**BEFORE THE PUBLIC UTILITY COMMISSION
OF OREGON**

LC 82

PACIFICORP, dba PACIFIC POWER,

2023 Integrated Resource Plan.

Figure 1. Difference in Installed Cumulative Capacity Between 2023 IRP Preferred Portfolio and Current Reality

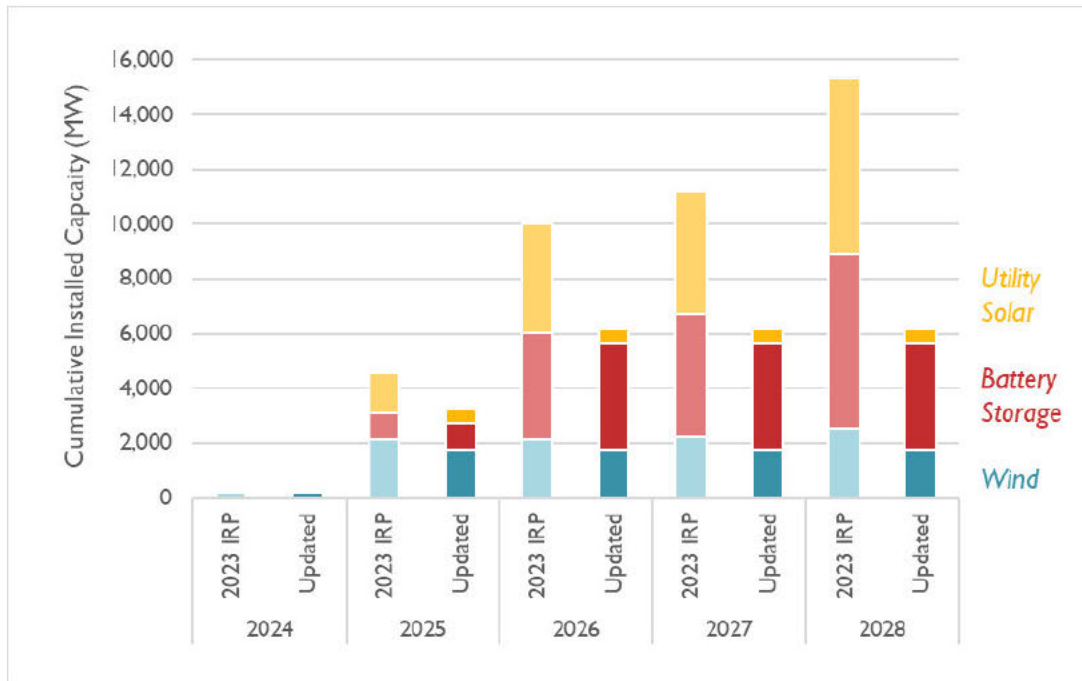
The figure below demonstrates the impact that this delayed procurement could have on renewable resource builds over the next five years. The “2023 IRP” chart series on the left represents the data as presented in the Preferred Portfolio. The “Updated” chart series on the right represents capacity that PacifiCorp has currently indicated it can procure based on the 2020AS RFP and bilateral storage contracts. Solar is the resource that is most at risk due to the 2022AS RFP suspension, as the 2020AS RFP did not result in a large number of solar additions and PacifiCorp has not indicated any alternative procurement processes for solar.

Figure 2. Reproduction of Figure 9.60 in IRP, with and without 2022AS RFP Suspension Impacts

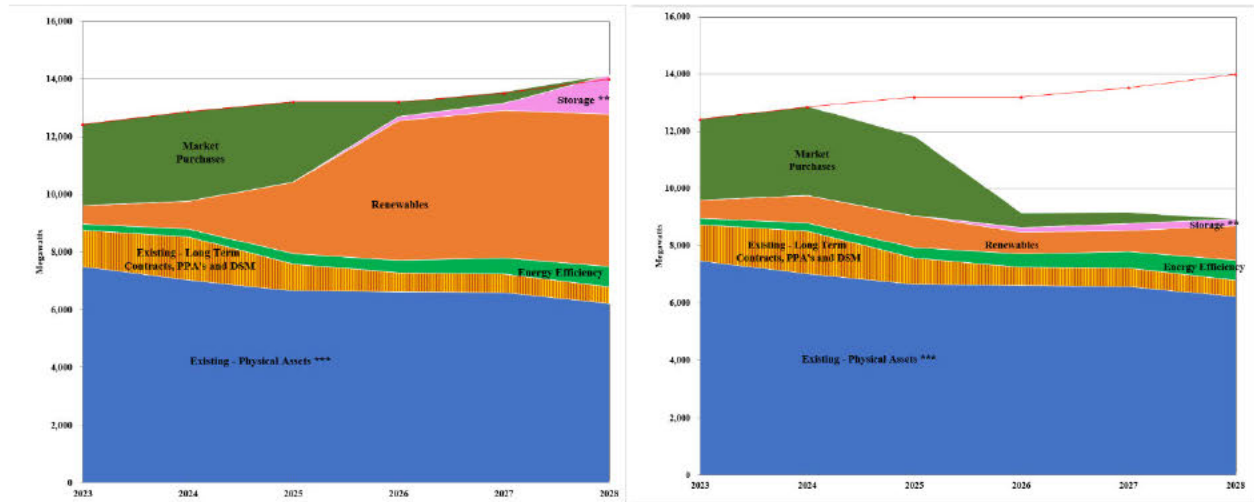
This delay will also have a significant impact on the generation mix of the system. Figure 9.60 in the IRP shows the projected generation by resource type for the Preferred Portfolio. Over the next five years, PacifiCorp’s Preferred Portfolio relied heavily on market purchases (also referred to as front office transactions or FOTs) and existing resources in the near-term while transitioning to rely more and more on new renewable resources. The left side of the figure below is a reproduction of Figure 9.60 as published in the IRP for years through 2028. The right side of the figure below demonstrates what the generation mix could look like if PacifiCorp does not procure new renewables and instead has a capacity mix that resembles the “Updated” chart series in Figure 9 above.

Without the guarantee of additional solar, storage, and wind resources coming online over the next few years, PacifiCorp may end up relying more heavily on FOTs or delaying thermal resource retirements relative to the Preferred Portfolio. This could lead to decarbonization risks, which the Company has not adequately addressed in the current IRP.

Figure 8: 3Comparison of Forecasted v. Actual Coal Use as Percent of Generation

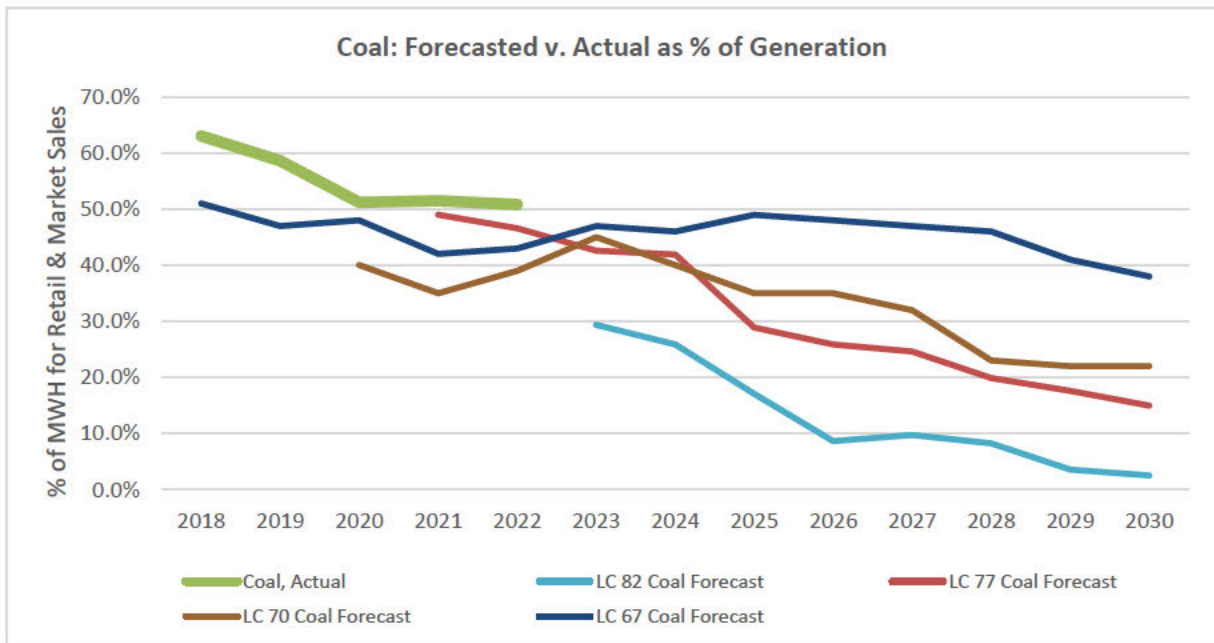
Staff conducted a brief analysis forecasted to actuals in an attempt to substantiate CUB’s comments regarding the disconnect between planning that uses a carbon price and actual coal operations.

Staff’s simple analysis would seem to corroborate CUB’s concerns regarding the realism of PacifiCorp’s modeled coal dispatch in the IRP. Staff raised a similar concern in UM 2225 in discussing the role of

Figure 9: Mid-term DRI Hours and Magnitude for the Western Interconnection

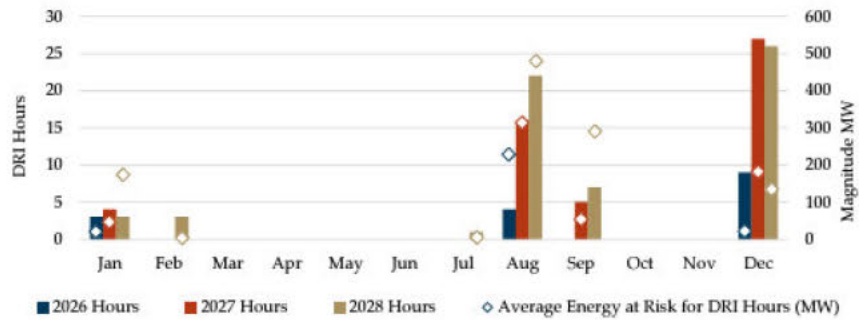
The WARA finds that a significant increase in Demand at Risk hours in December can be attributed to increased load forecasts in the Northwest, while there are relatively few utility-scale resource additions planned in the Northwest. The WARA concludes that load serving entities may need to delay resource retirements if they cannot mitigate these risky hours in the next two years. However, we note that WARA may have less visibility into local small-scale supply and demand resource activity that could reduce the at-risk hours in those out years.

Notably, PacifiCorp’s IRP relies on 944 MW of summer market purchases in 2027 and 493 MW in 2028.¹³⁴ Given WECC’s showing of regional resource adequacy risk during August in those years (red bars in Figure 4 above), the expectation of nearly 1 GW of market energy being available for purchase during summer peak hours seems potentially risky. Further, PacifiCorp has suspended the 2022AS RFP that would have brought resources online from 2025 through 2027, further increasing the region’s resource adequacy risk.
